PLANNING COMMISSION AGENDA

DATE: JULY 18, 2023

RE: Site Plan Review and Special Land Use – 8464 W Mt Morris Road

RE: Site Plan Review – 8464 W. Mt. Morris Road – Valero Mt. Morris Road

PROPOSED BUILDING INTERIOR PLAN

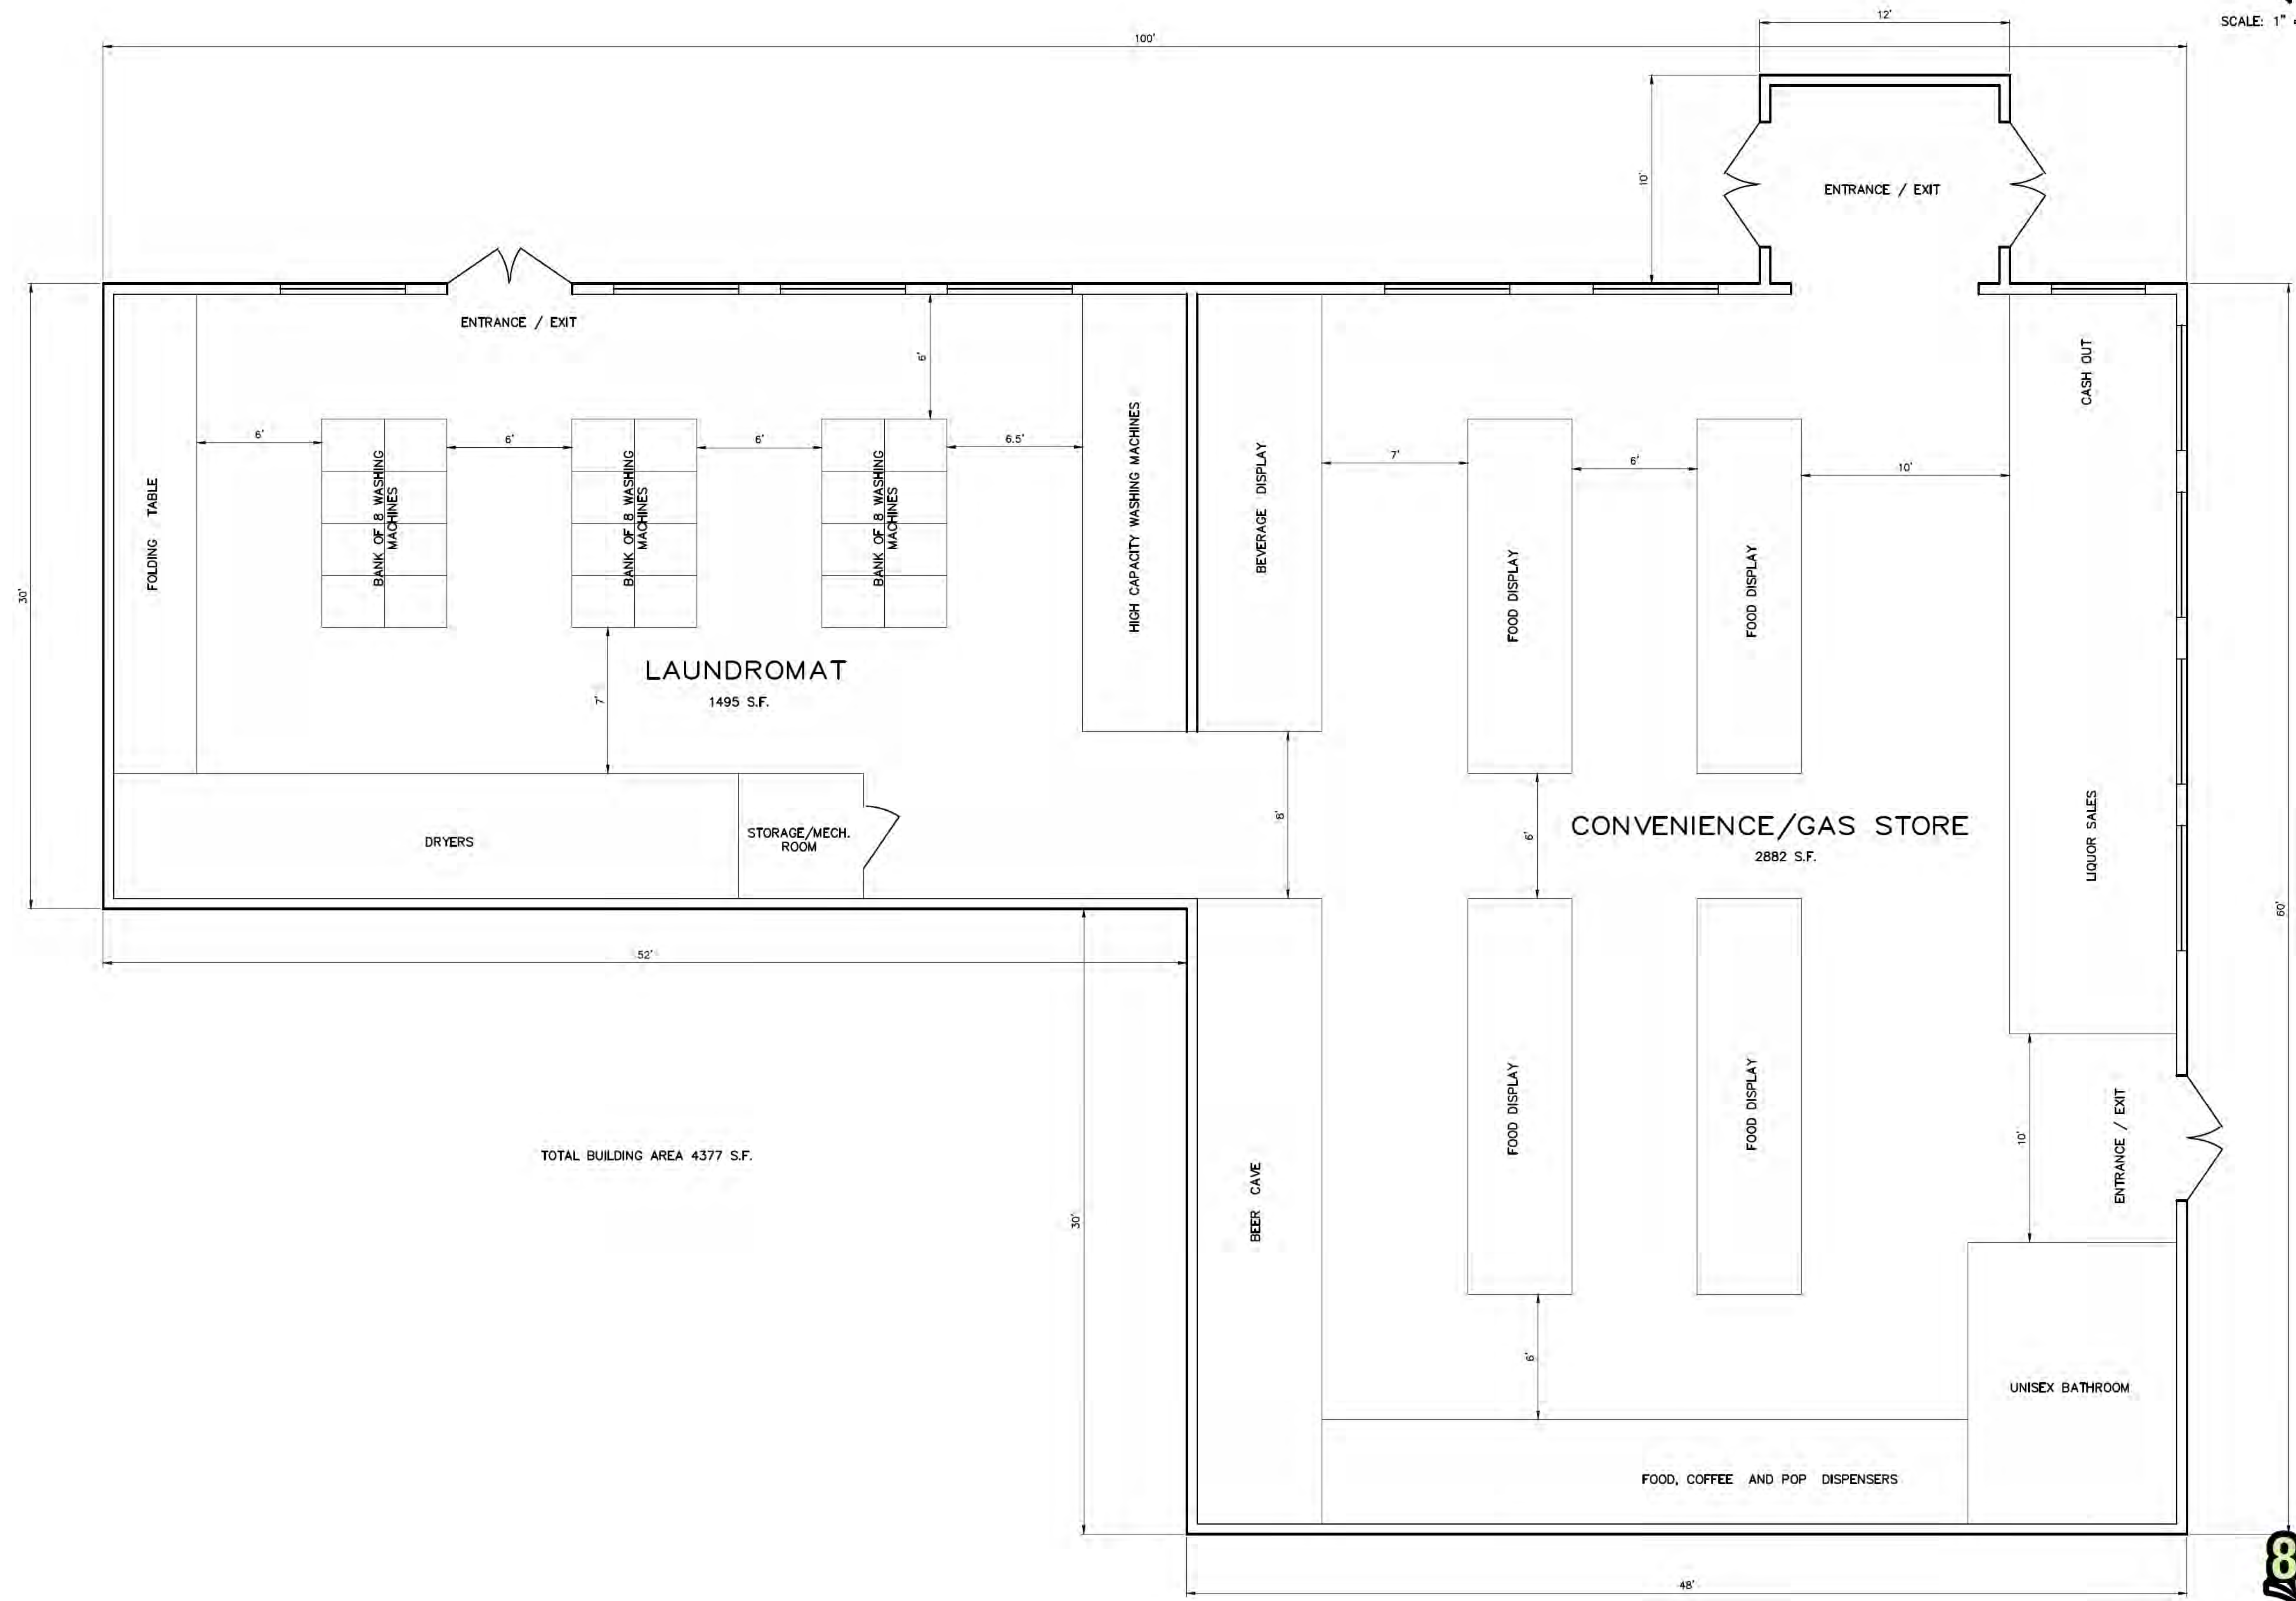
3. A proposed interior plan has been provided, but no existing interior plan has been included for comparison or assessment of the need for sewer and or water improvements.
